RE: Skagway Ore Peninsula Redevelopment Descoping Pricing

Please find attached Pacific Pile & Marine's (PPM) proposal for the Skagway Ore Peninsula Redevelopment De-Scoping Pricing based on drawings received 07/05/2023 and discussions thereafter.

ORE PENINSULA REDEVELOPMENT
SKAGWAY, ALASKA

GENERAL PILE SCHEDULE

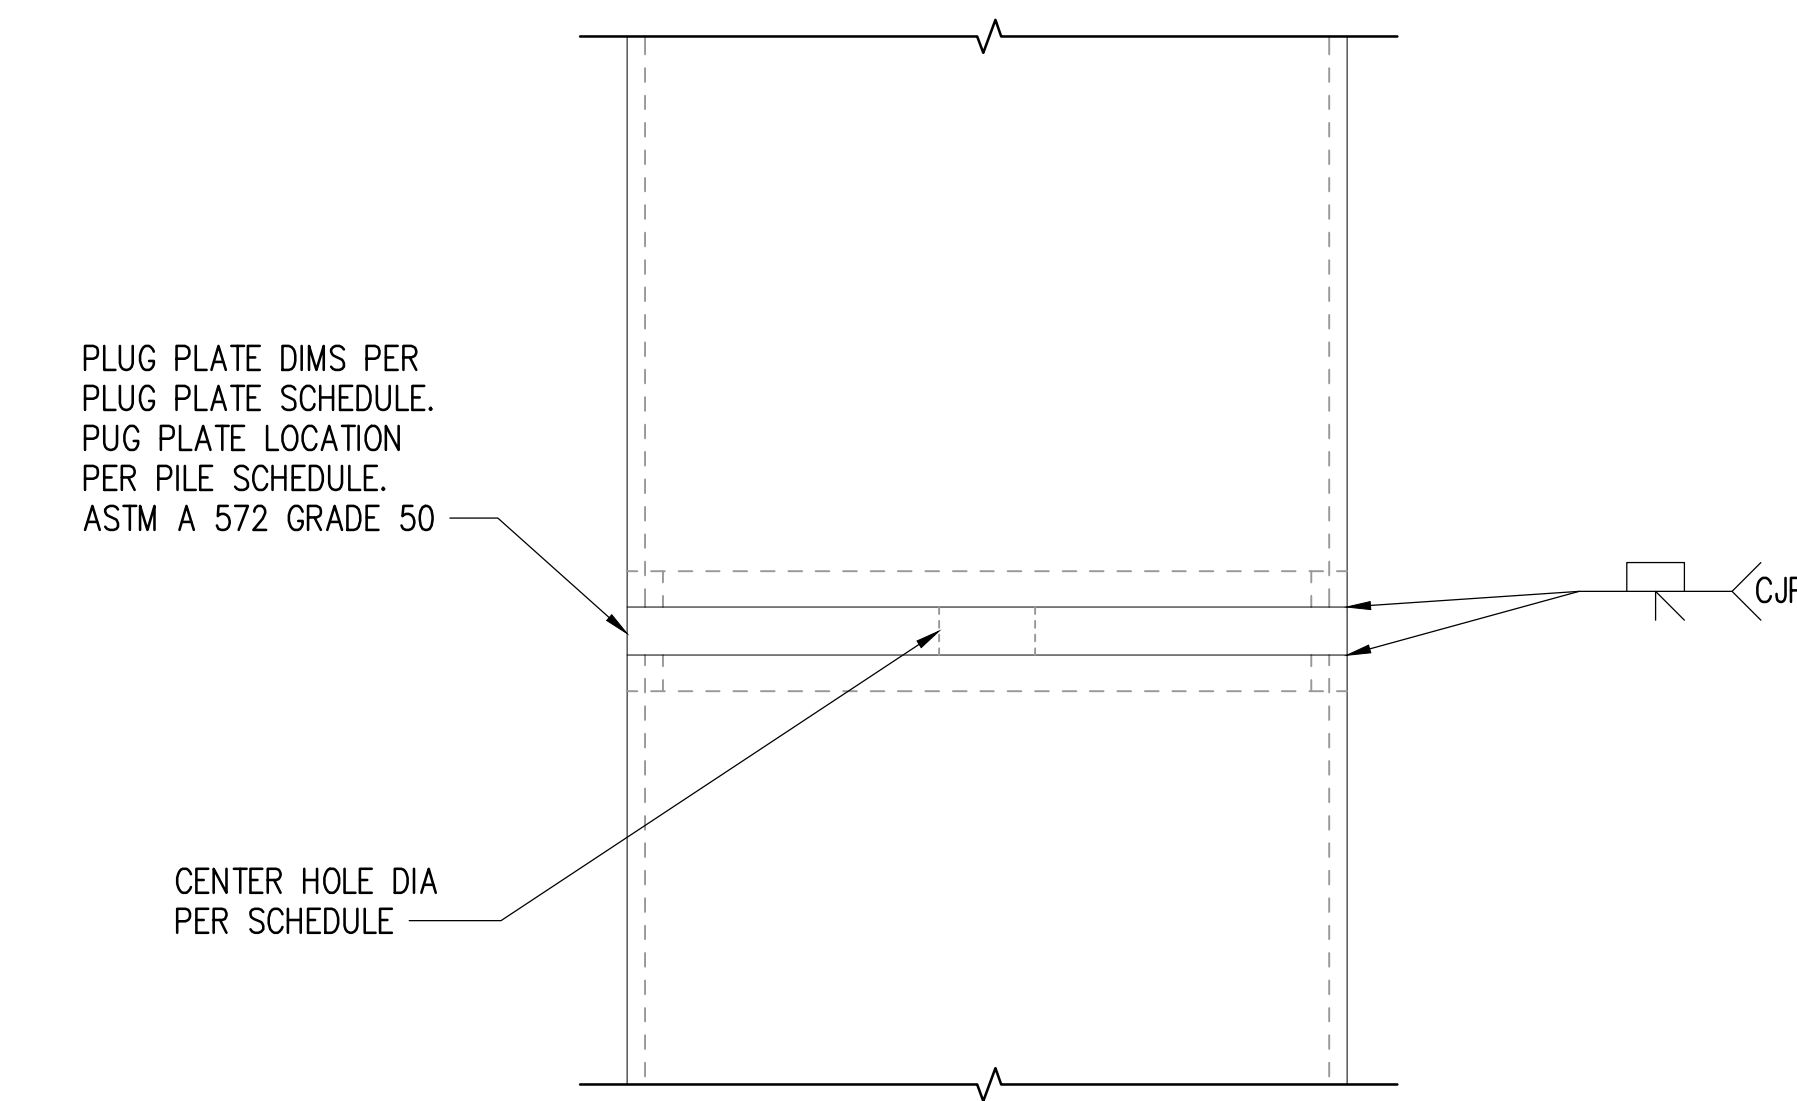
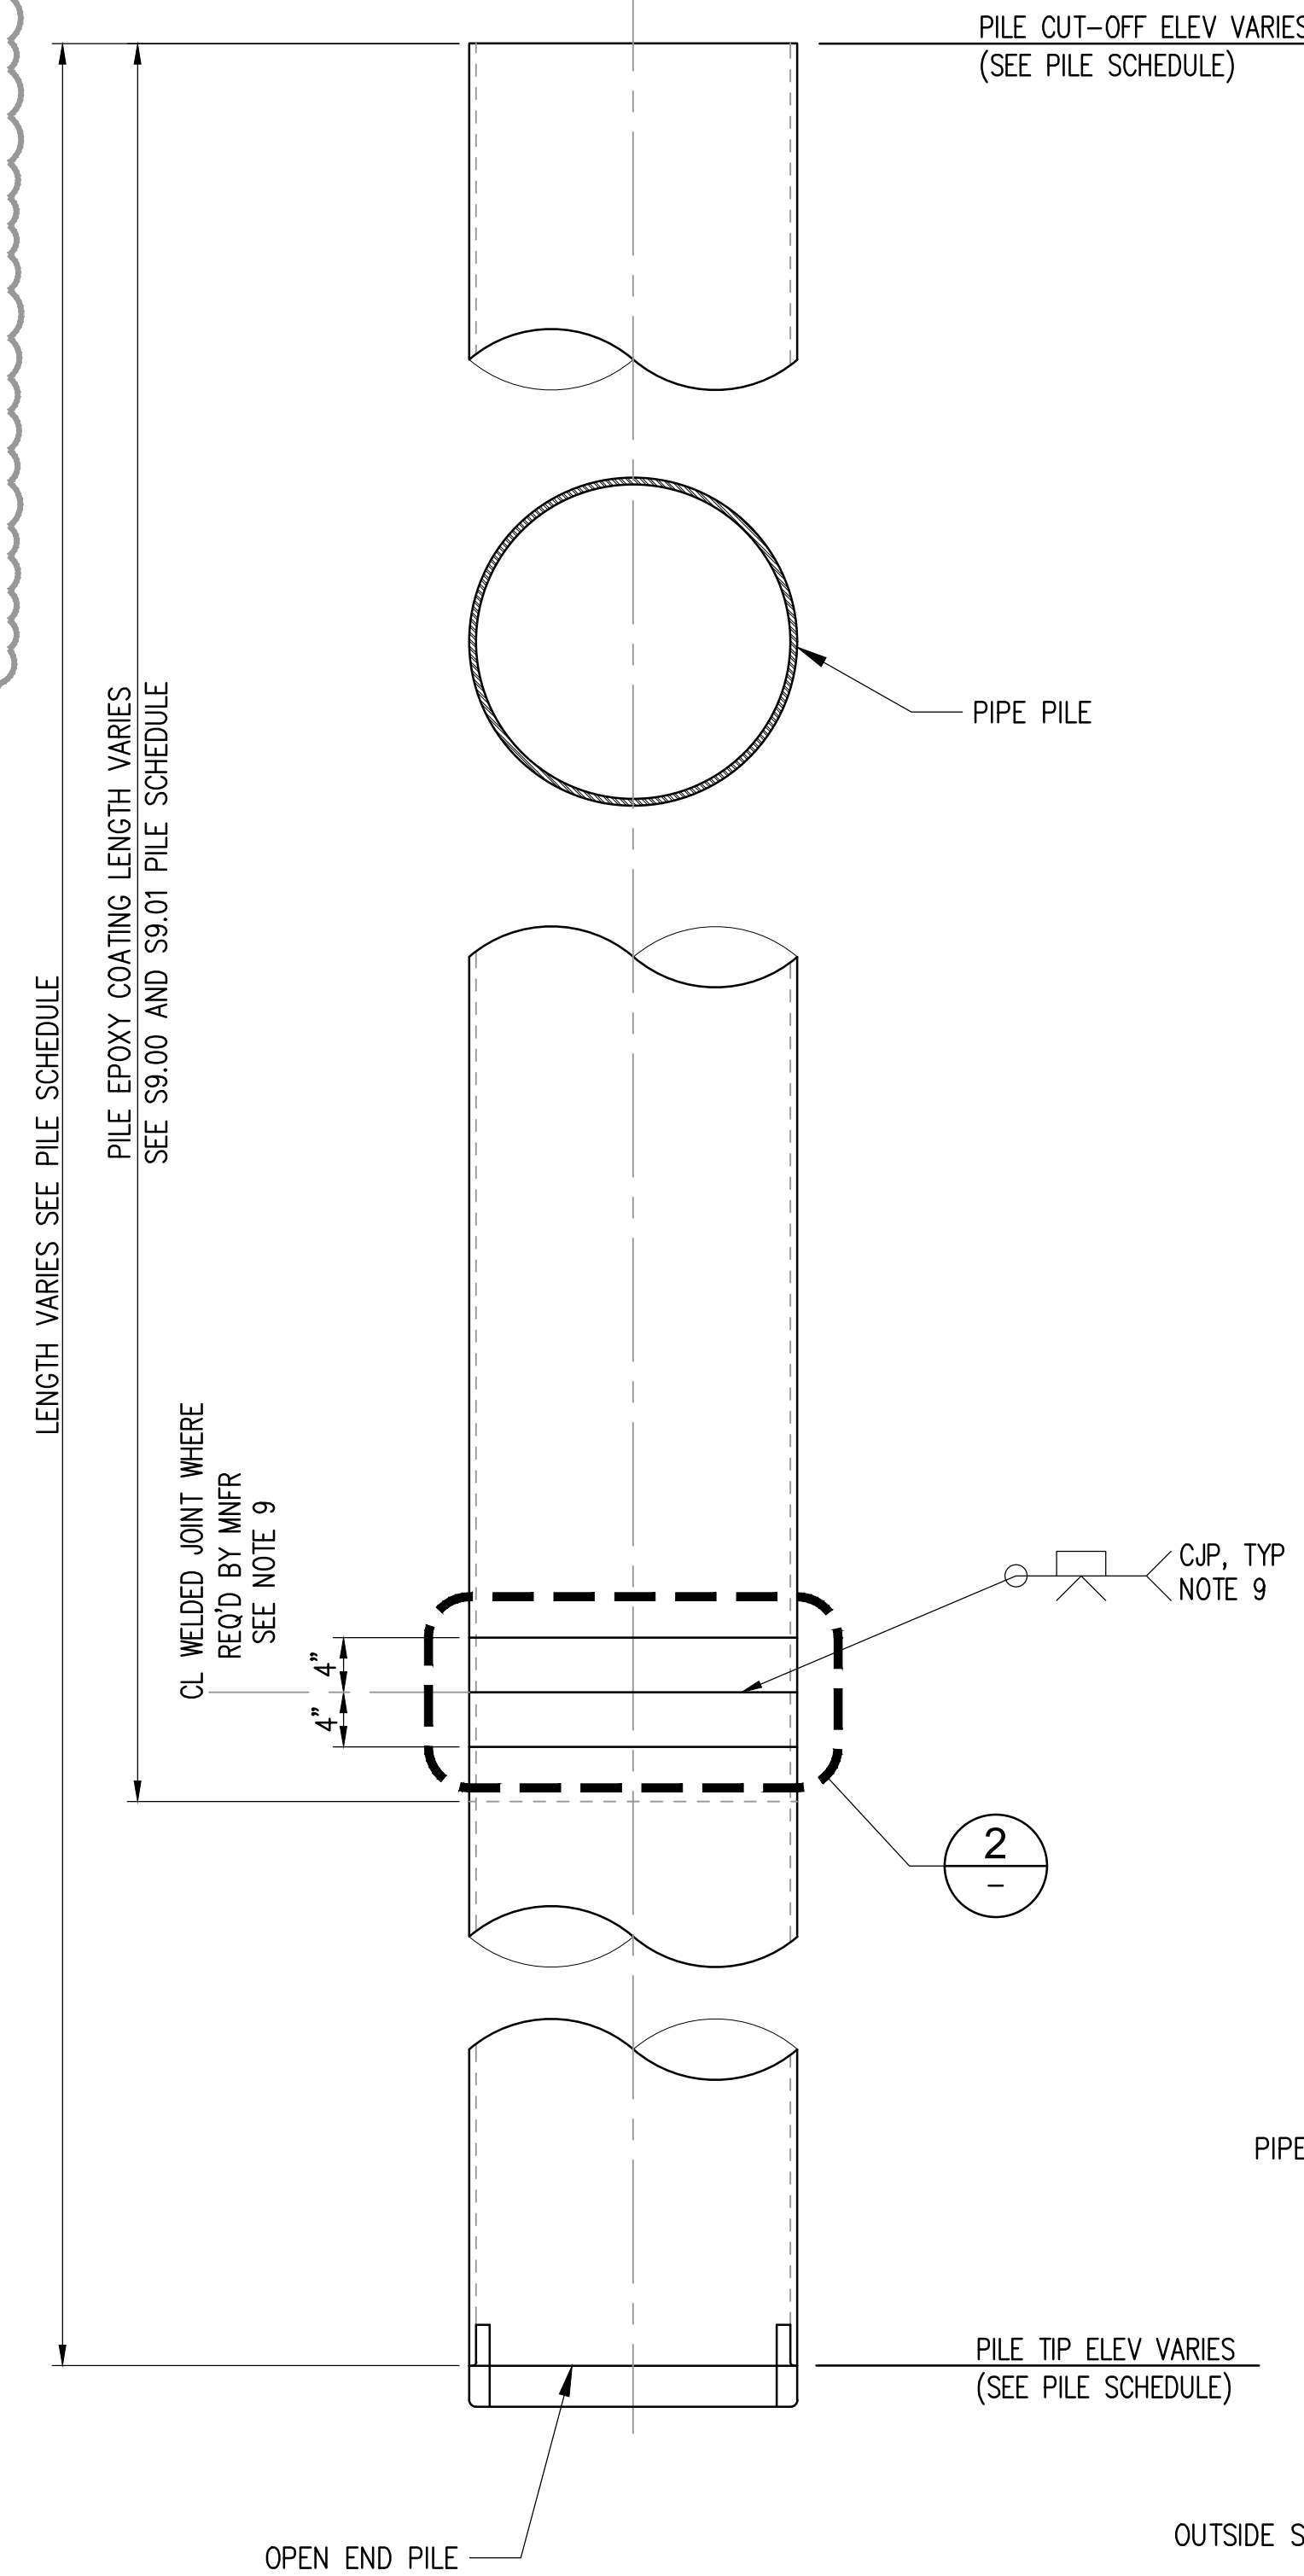
Piles to be installed in new scope

~~Piles not included in new scope~~

TEMP FUEL LINE RE-SCOPE 7.7.2023

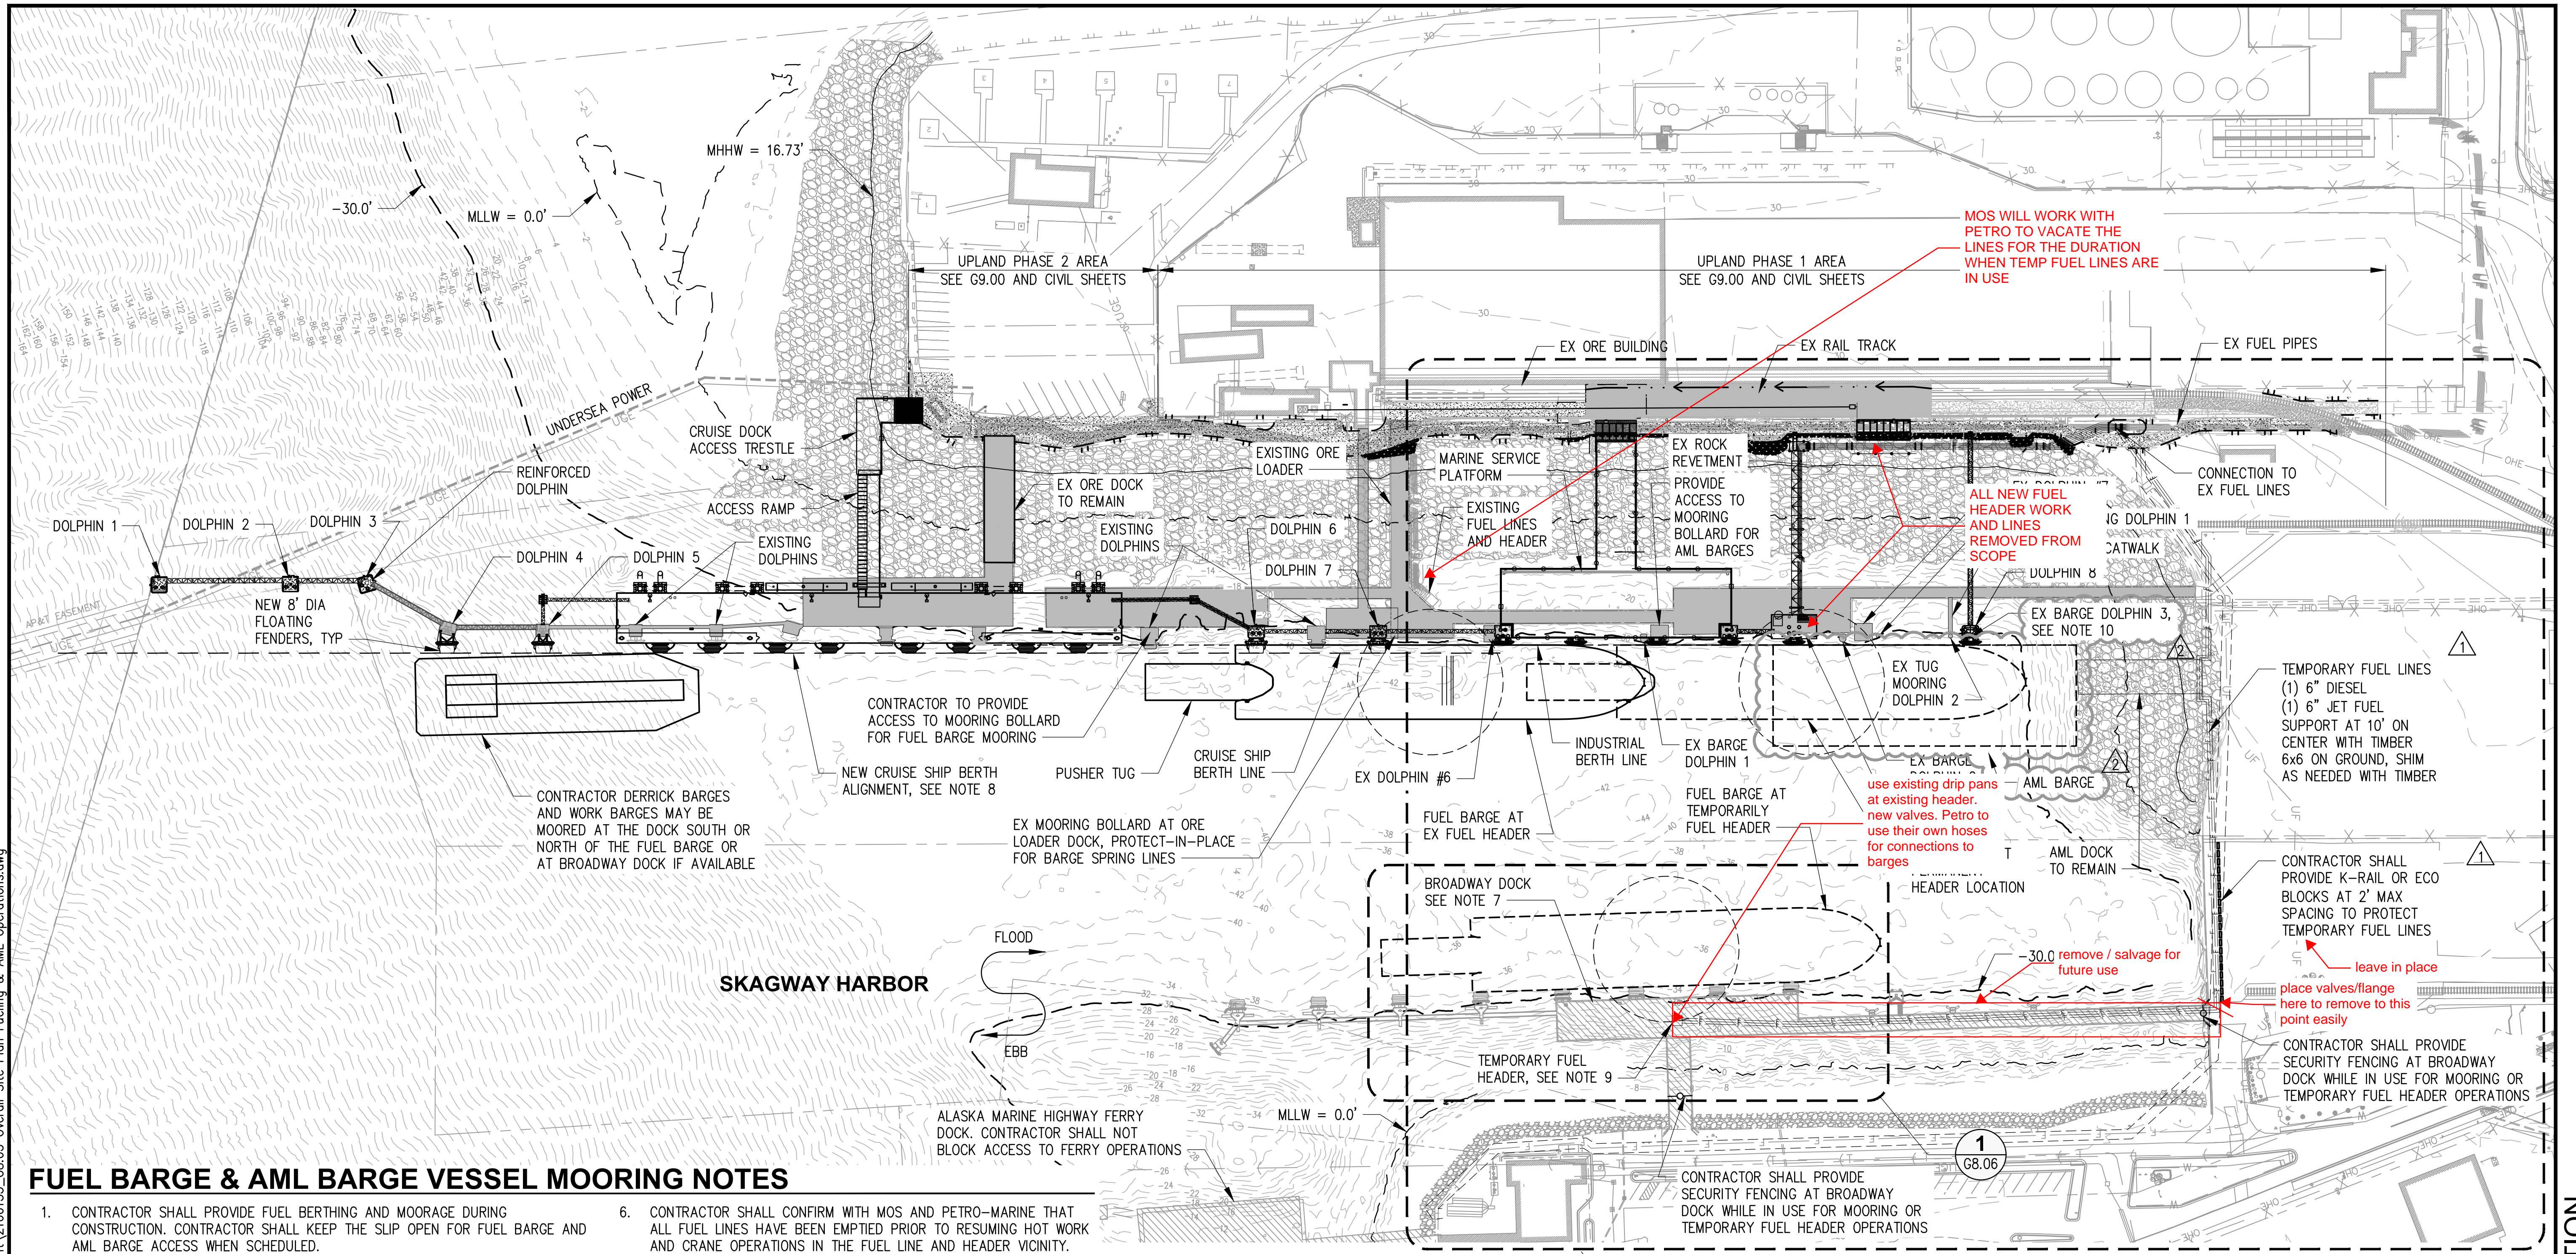
1. Design, supply, and install two temporary fuel lines. The temporary fuel lines will be commissioned by Haskell. Temporary fuel line scope is based on KPFF mark-ups provided on 7/7/2023. KPFF and Petromarine to assist with developing mutually agreeable tie-in plan. Piping at tie-ins will be made safe for hot work by others.
2. Haskell will drain the temporary fuel lines prior to demolition. The temporary fuel lines will be cut into segments less than or equal to sixty feet (60') for removal by others. Demolition of the temporary fuel lines will be limited to piping on the Broadway Dock only. Jersey barriers will be supplied, installed, and left in place.
3. Supply and install temporary hangers at the AML Dock.
4. Supply, install, and remove designed two four (4) foot by eight (8) foot steel plates at the AML dock.
